SKEP III Home Office Support Site Visit Report

Consultant	Wahib Medanat Consultant Engineer	Rep No.	22-17072022
Contractor	Dijlah Establishment Constr. Contracting	Tender No.	(11/2019/USAID/SKEP/3/S) Schools for a Knowledge Economy Project (SKEP) - Phase (3) Package (1, 2)
Site Name	Thahr Al Sarow Basic School for Boys- Jerash	Day/ Date	Wed. 17/07/2022
Duration of Project	450 Calendar Days	Total Project Budget	8,314,983.735 JD

(Figure: 19)

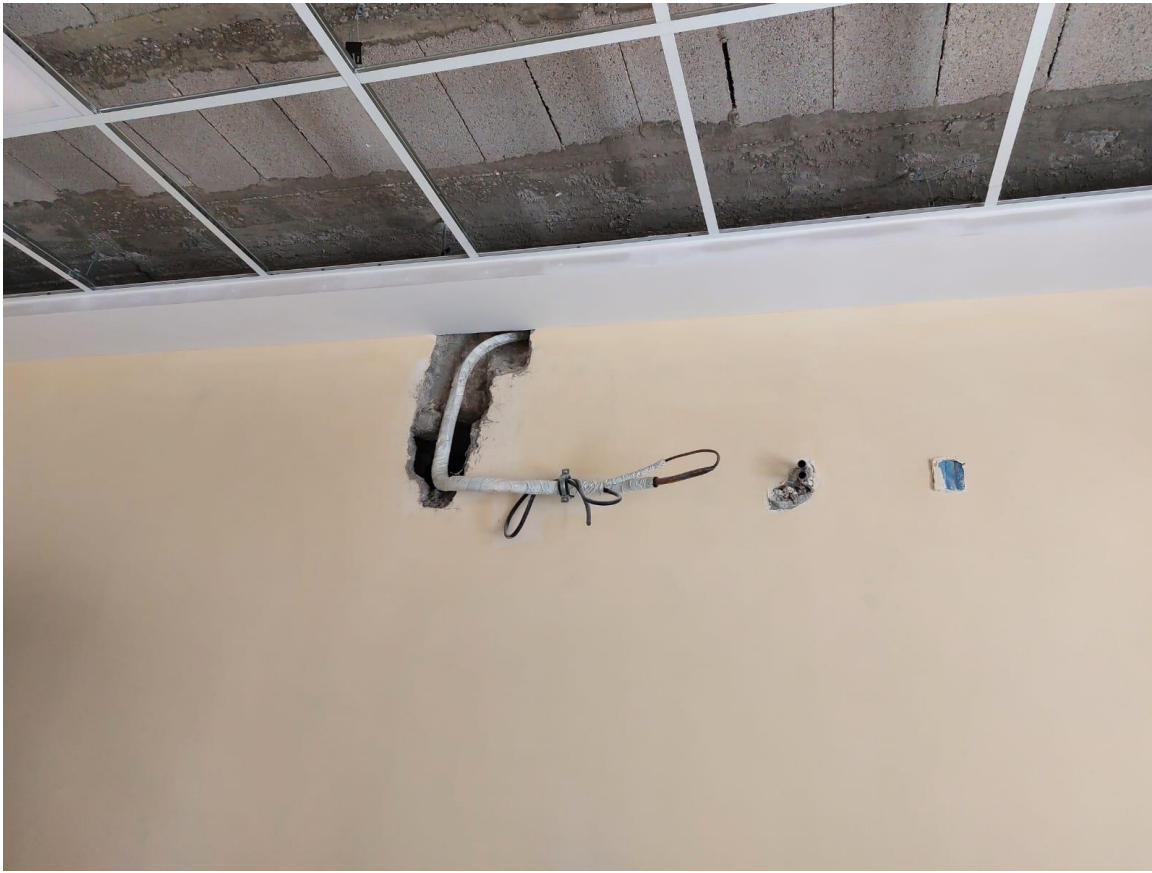
The team requested the Contractor to continue in the rectification of the installed granite coping at the staircase

(Figure: 21)

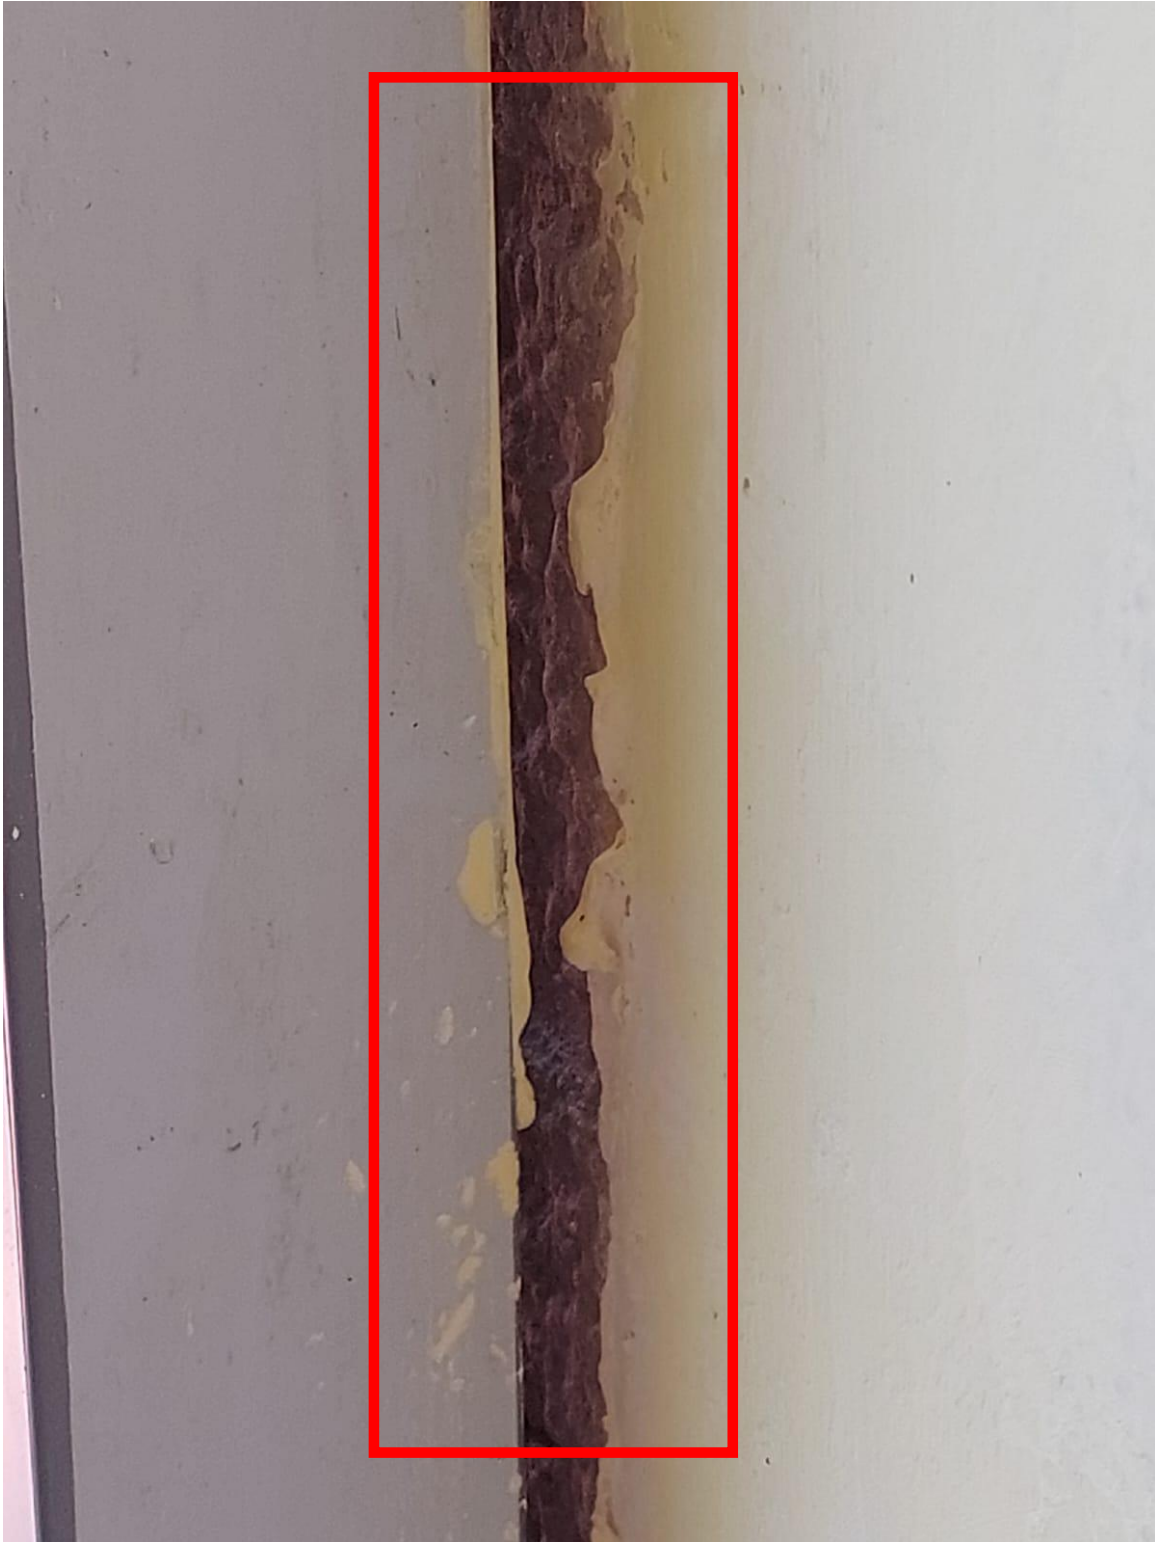
The team observed that the Contractor installed the frame for the suspended ceiling before the completion of finishing work around the mechanical pipes in the wall. The team requested the Contractor to dismantle the frame and finalize the finishing work around the pipes

(Figure: 26)

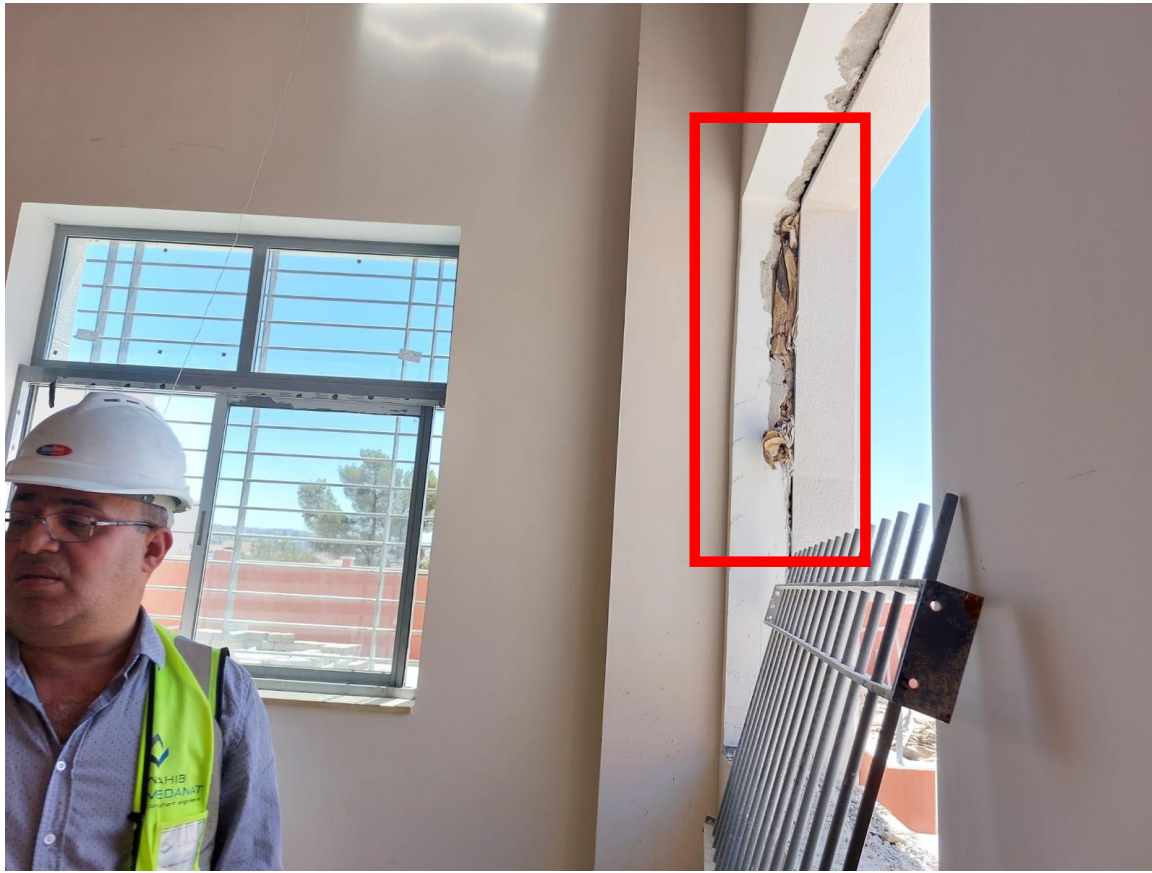
The team observed that the Contractor haven't abide by the previously given instructions regarding the executed porcelain wall tiles at the building entrance- ramp area. The Contractor was requested to remove the dark colored strip to be replaced with the light colored tiles at the wall adjacent to the staircase
